# Service Bulletin

Bulletin No. 2017-66

# Volkswagen Marine 3.0L TDI Tier II Oil Line Sealing Washers, EDC Calibration, Turbocharger Load Distribution Ring, and Exhaust High Riser Updates

**Green dot placement**  
**a** - Green dot  
**b** - Oil extraction pump button  
**c** - Central electrical panel

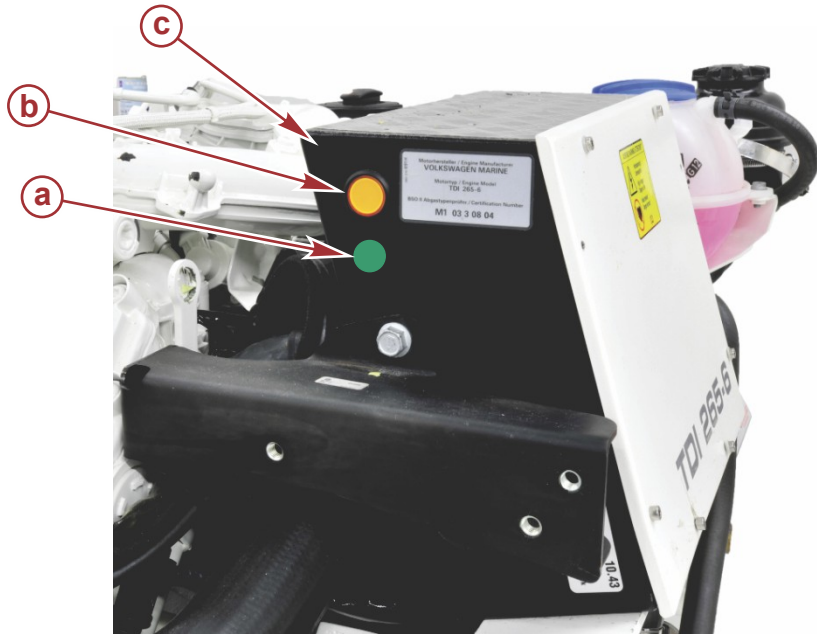
- Inspect for a green dot on the side of the central electrical panel near the oil extraction pump button. The green dot represents that the updates have been completed by the factory or an authorized dealer and no further action is required. No green dot represents the updates need to be done.
